ZONING AMENDMENT,
PLANNED UNIT DEVELOPMENT &
SUBDIVISION STAFF REPORT

Date: March 20, 2008

<u>NAME</u>	Joseph Mramor
<u>SUBDIVISION NAME</u>	Mramor's Addition to Weinacker Avenue Subdivision
<u>LOCATION</u>	900 Weinacker Avenue (Southwest corner of Weinacker Avenue and the Illinois Central Gulf Railroad right-of-way, extending to the Southeast corner of Old Canal Street and Sunset Avenue)
<u>CITY COUNCIL DISTRICT</u>	District 3
<u>PRESENT ZONING</u>	R-1, Single-Family Residential
<u>PROPOSED ZONING</u>	B-3, Community Business
<u>AREA OF PROPERTY</u>	1 lot /6.0± Acres
<u>CONTEMPLATED USE</u>	<p>Subdivision approval to create one lot, Planned Unit Development Approval to allow two buildings on a single building site, and Rezoning from R-1, Single-Family Residential, to B-3, Community Business, to allow light warehousing.</p> <p>It should be noted, however, that any use permitted in the proposed district would be allowed at this location if the zoning is changed. Furthermore, the Planning Commission may consider zoning classifications other than that sought by the applicant for this property.</p>

SITE PLAN

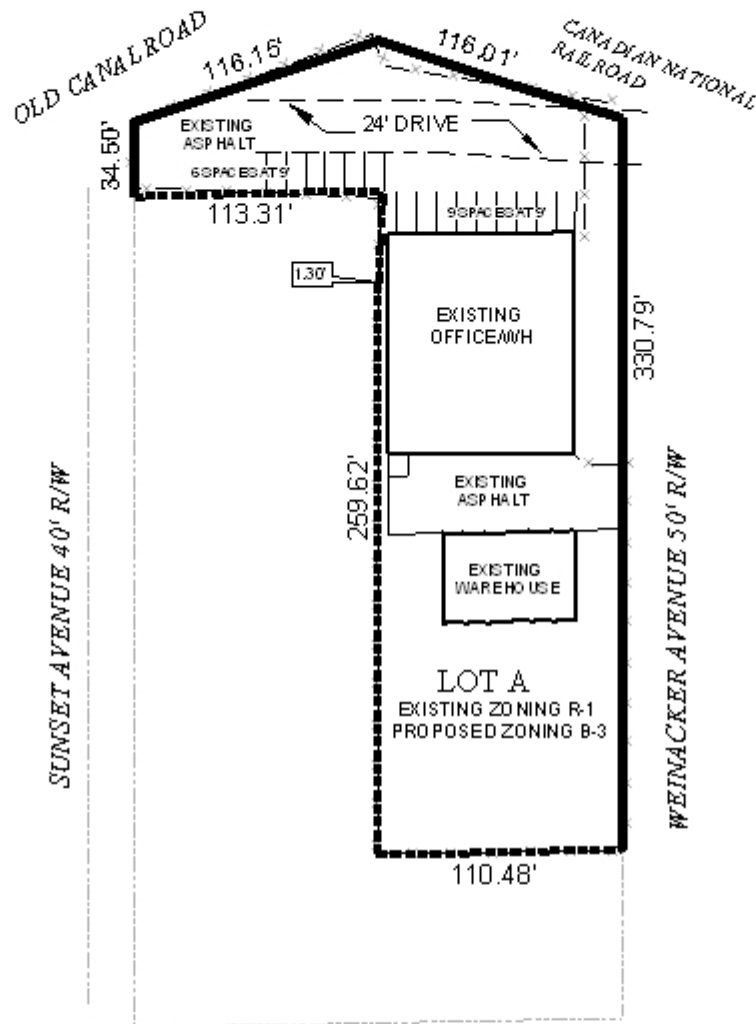
The proposed site/layout plan indicates that the proposed parking area layout and buffer requirement. The site plan does not reflect which street the curb cuts are proposed, however, the site should be allowed one curb cut to Old Canal Street and two curb cuts to Weinacker, with the size, design and location to be approved by Traffic Engineering and conform to AASHTO standards.

The proposed re-development illustrates no on-site access to the property by large transports, and the proposed re-development will not facilitate movement on the site in terms of on-site circulation by a large transport. Fifteen parking spaces are proposed, however, as part of the development; however, no calculations are provided to verify if the site will comply with the parking requirements of the Ordinance. As stated, loading areas for the site also appear to require use of the public right-of-way by trucks to execute the turning movements necessary to access the existing building.

No on-site storm water detention facilities are depicted on the site plan, however such facilities may be required due to the extent of the proposed re-development.

There is no indication on the site plan as to the proposed location of any dumpster or other waste storage facility. The location of the storage area for the dumpster must be indicated on the site plan, and the location and required screening must comply with Section 64-4.D.9. of the Zoning Ordinance, as well as with all other applicable regulations.

The site plan should also be revised to depict the existing parking and/or vehicular circulation for the remainder of the site.

The site fronts onto Old Canal Street, Weinacker Avenue, and Sunset Avenue, all minor streets. The right-of-way for Old Canal Street and Weinacker Avenue appear to be adequate, but the right-of-way for Sunset Avenue illustrates 40-feet, which is inadequate. Therefore, the plat and site plan should be revised to provide a minimum width of 25 feet from the centerline of the Sunset Avenue right-of-way, as required in Section V.B.14. of the Subdivision Regulations.

The site has property lines at one intersection. Section V.D.6. of the Subdivision Regulations requires that *“property lines at street intersection corners shall be arcs having radii of at least 10 feet or shall be chords of such arcs.”* The plat and site plan should be revised to reflect this requirement at the Old Canal Street/Sunset Avenue intersection, with the size of the radius to be approved by Traffic Engineering and conform to AASHTO standards.

The 25-foot minimum building setback line, required in Section V.D.9. of the Subdivision Regulations is not shown on the preliminary plat. Due to the street right-of-way dedication and the intersection curb radii requirements previously stated, the minimum building setback line should be revised to reflect these requirements, and should be depicted on both the site plan and the plat.

- 1) failure to submit revision of the site plan to depict proposed dumpster storage locations, in compliance with Section 64-4.D.9. of the Zoning Ordinance;

- 2) failure to submit revision of the site plan to depict existing on-site circulation and parking;
- 3) failure to submit placement of a note on the site plan stating that lighting shall be so arranged that the source of light does not shine directly into adjacent residential properties or into traffic;

- 4) failure to submit revision of the site plan and plat to provide a minimum right-of-way width of 25 feet, as measured from the centerline for Sunset Avenue, in compliance with Section V.B.14. of the Subdivision Regulations;

- 5) failure to submit revision of the site plan and plat to provide the appropriate radii at the street intersection corners, in compliance with Section V.D.6. of the Subdivision Regulations;

- 6) failure to submit revision of the site plan to accurately depict all existing curb-cuts, and modifications thereof (with reduction of excessive width curb-cuts where possible), as well as proposed curb-cuts;

- 7) failure to submit depiction of a fence and landscape buffer, where the site abuts R-1 properties, as required by Section 64-4.D.1;
- 8) failure to submit revision of the site plan to provide full compliance of the landscaping and tree requirements of the Ordinance for the entire site; and

- 9) failure to submit revision of the site plan and plat to depict the 25-foot minimum building setback line for the entire site, adjusted as necessary to accommodate the right-of-way dedication for Sunset Avenue, in compliance with Section V.D.9. of the Subdivision Regulations.
